City of Mississauga Memorandium: City Department and Agency Comments

File(s): A390/20 Ward: 1

The applicant requests the Committee to approve a minor variance to allow accessory structures proposing:

Property Address: 16 Oakwood Avenue South

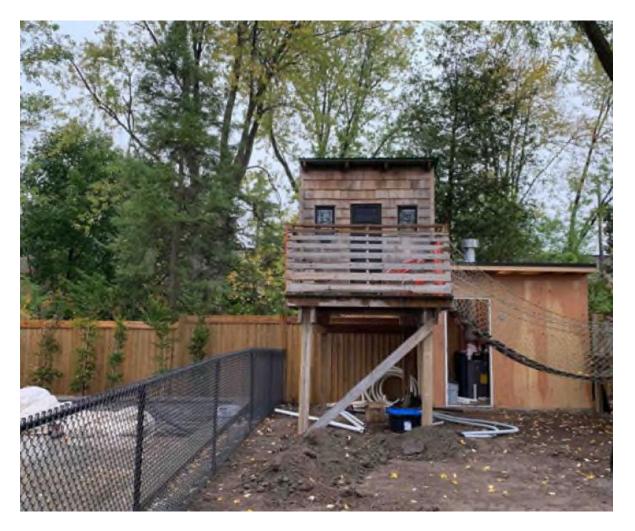
Enclosed for Committees easy reference are photos depicting the existing structures. Should Committee see merit in the applicant's request, we request that both structures be equipped with an eaves trough on the rear side of the structures and a down spout directed internally in such a manner as to not impact the adjacent lots.
